ALTERATION OF A LOCAL HISTORIC DISTRICT (LHD) PROPERTY
STAFF REPORT

Site: 64 Meacham Road

Case: HPC.ALT 2021.17

Proposal: *Exterior alterations*

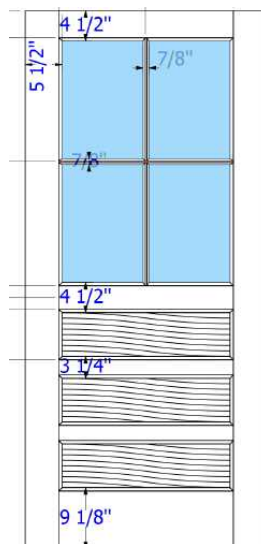
Regarding the new left elevation window openings, as-proposed there will be three different sizes of window openings on the same façade that do not have any relationship to each other. While the narrow window proposed on the left elevation can draw some relationship to the narrow side windows in the front bay, those windows are also one-over-one. The remaining two new window openings proposed on the left façade may relate to each other, but to no other window on an elevation regulated by the Commission. These two windows should be standardized to match the original window openings on the front and right elevations of the building that are visible from the public way

4. Windows on the main façade and within the Mansard roof shall be two-over-two simulated divided light, exterior aluminum clad with a matte, baked finish. Dark spacers between glass. Grids applied over the glass. No mirror-like reflections, no warped reflections, and no tinting is permitted. All windows shall be identically sized.

Name : DARLING 4418

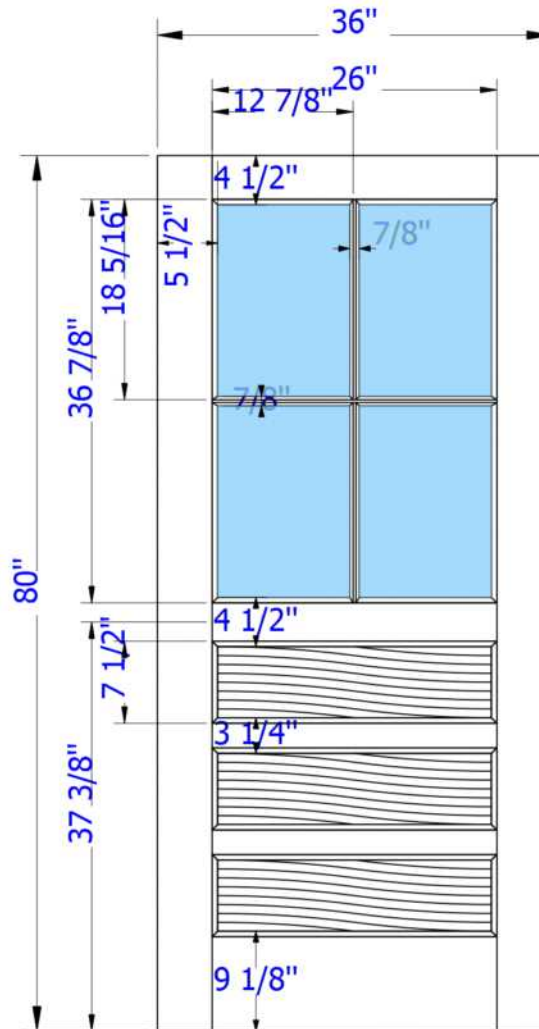
The proposed front door will remain in its current location. Because it is a change-out of a (later) door, the HPC must review the design and materials. The proposed door is made of fiber panel and presents three horizontal bottom panels topped by a glass insert with four simulated divided lites. The image provided by the Applicant is what is shown below. This and other proposed materials provided by the Applicant that fall under the HPC's purview are also appended to this staff report>

Preservation Planning Assessment: The style and material of the door is not reflective of what was used in the Second Empire period. Multiple manufacturers produce solid wood doors with period-appropriate details.

22. Front door shall be solid wood and of a period-appropriate style such as double-arch upper and panels lower section; single-arch upper and paneled lower section. Photographic samples and specs shall be submitted to Preservation Planning for their review and approval prior to the issuance of a building permit by ISD. Front door shall be painted.

Interlocking Natural Thin Veneer System

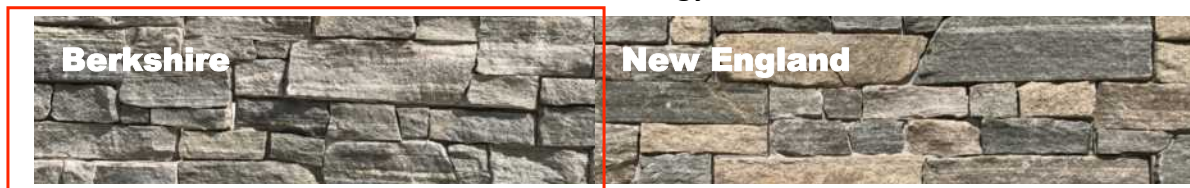
Preservation Planning Assessment: Concrete and railroad tie curbing currently exists. As a change in materials is being proposed, this comes under the Commission's purview. Preservation Planning Staff recommends a granite cap which should interplay well with the grey granite veneer.

23. Replacement curbing along the perimeter of the grass area at the front of the property shall be a grey granite veneer, color "Berkshire". Capping shall be granite.
